BASELINE
ENVIRONMENTAL CONSULTING

6 October 2009
Y0323-03.01342

Subject: Addendum I to Work Plan for Additional Soil and Groundwater Investigation, 751-785 Seventh Street, Oakland – SLIC Case RO0002586 and Geotracker Global ID SL0600130797

Figure 2

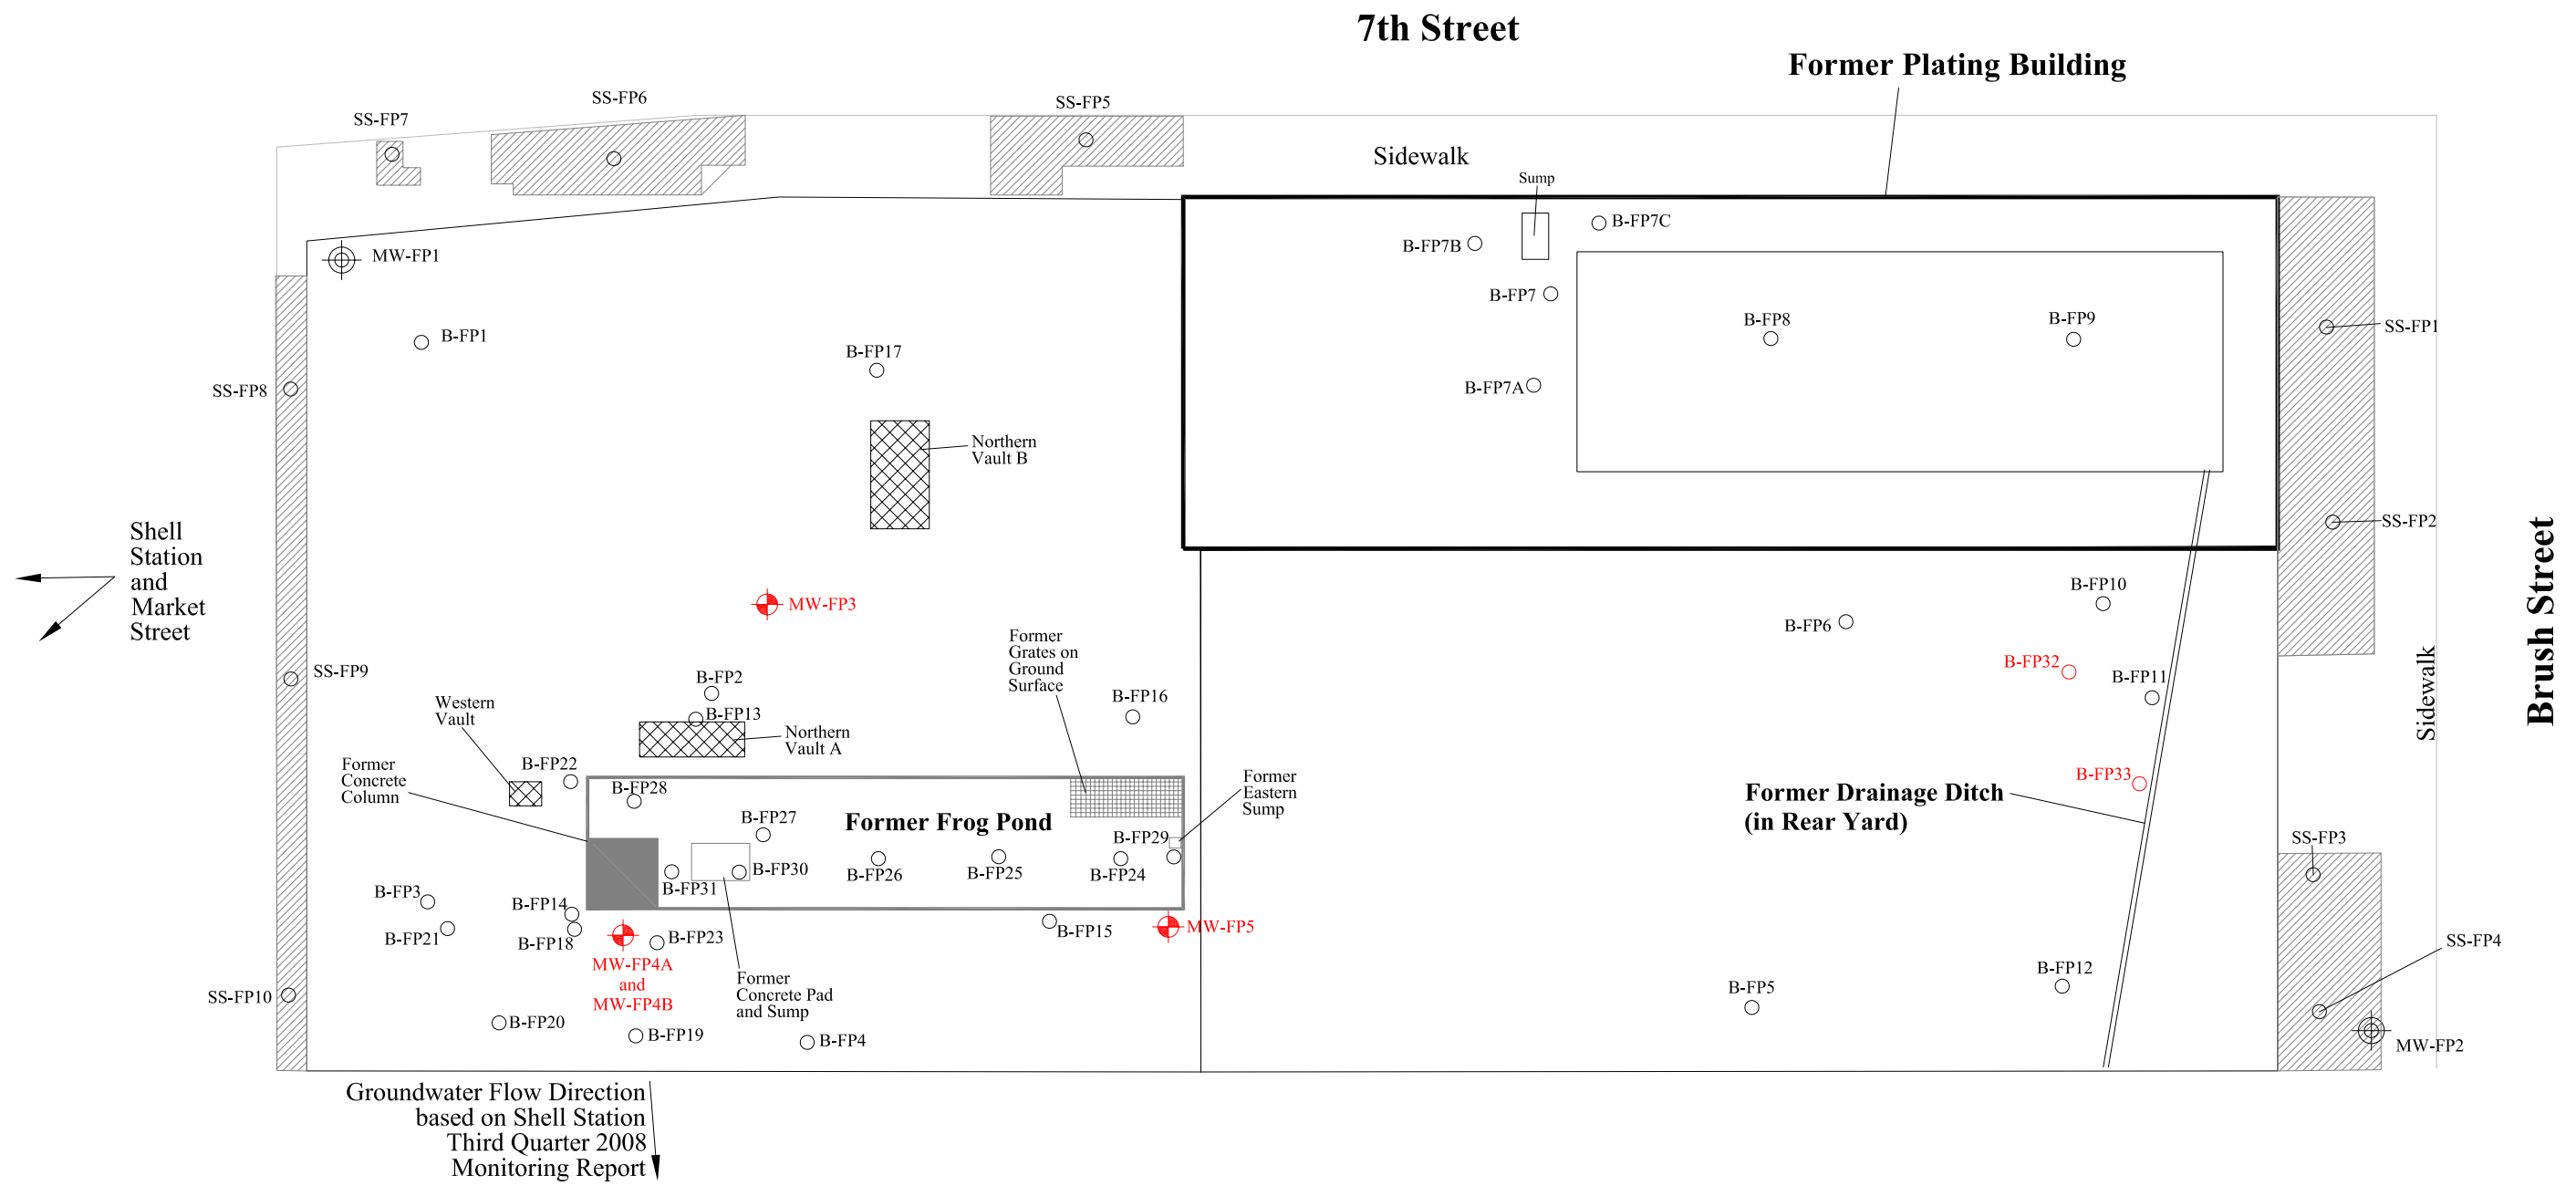
The Brush Street Group's involvement with the site began long after the site had been abandoned and cleaned up by the U.S. Environmental Protection Agency and has no knowledge regarding the intended purpose of the drainage ditch in the rear yard. The ditch has been sealed by the Brush Street Group and no longer exist. Since historical plating operations appeared to have been located across the rear yard, the drainage ditch likely captured rain runoff and possibly spilled liquids. It appeared that the ditch once drained into the depressed vault inside the former plating building. Historical documents available to the Brush Street Group indicate that liquids from the vault was once discharged to the sanitary sewer.

Soil samples collected at 0.5-1.0 and 3.5-4.0 feet bgs from boring B-FP11 in 2005 contained elevated metal concentrations. We propose to install two borings in the vicinity of B-FP11 to a depth of approximately eight feet bgs. One boring would be located about ten feet west of boring B-FP11 (away from the drainage ditch) (B-FP32), and the second boring would be located about ten feet south of B-FP11 (adjacent to the former drainage ditch) (B-FP33) as shown on Figure 2. Soil samples would be collected from approximately 0.5-1.0, 4.0-4.5 and

7.5-8.0 feet bgs from each boring, and analyzed for Title 22 metals and hexavalent chromium.
